From: Blacker, Katherine <blackerk@grotonutilities.com>
Sent: Monday, April 27, 2026 12:56 PM
To: Hannah Gienau; Elizabeth Burdick; Anna Wynn
Cc: LaFontaine, Doug; Acimovic, Karl; Monk, Cassidy; Pratt, Joseph; water pollution control authority
Subject: Comments - 1947 Center Groton Road Residential Development - WIP#2-1864
Attachments: 1947 Center Groton Rd_WIP02-1864_GU Water & Watershed Comments_04-24-26.pdf; GU WATER SPECS._SELECTION.pdf; L0098_Water Main Record Plan.pdf

CITY OF GROTON
DEPARTMENT OF UTILITIES
SITE PLAN REVIEW SHEET

Title of Plan Multifamily Residential Dvlpt. - 1947 Center Groton Rd Latest Revision Date 04/22/2026

Location 1947 Center Groton Road, Ledyard Center W.I.P. # 02-1864

Gate valve on both sides of hydrant -
for isolation

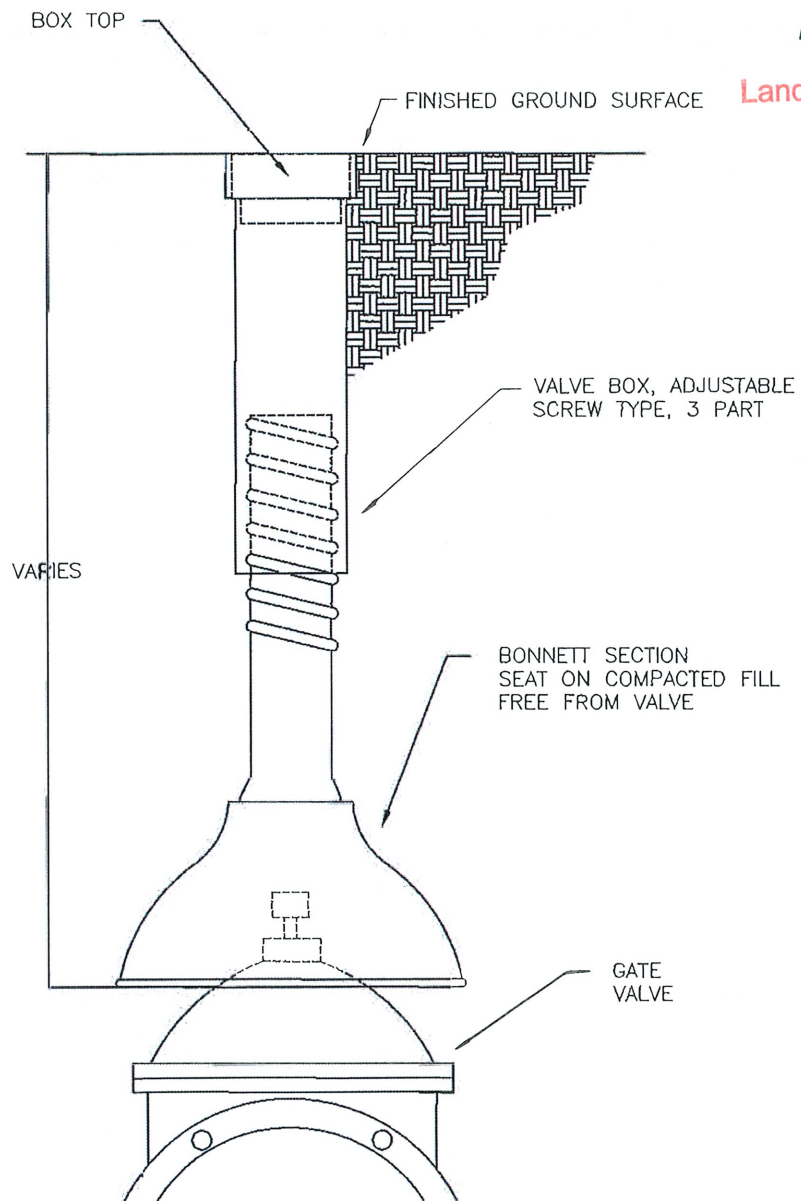
- c. Note 6' min. horizontal separation from UG telecommunications and electric.
 - d. Recommended showing additional gate valves at driveway entrance for isolation, and three-way valves at all hydrants.

- e. See images below:
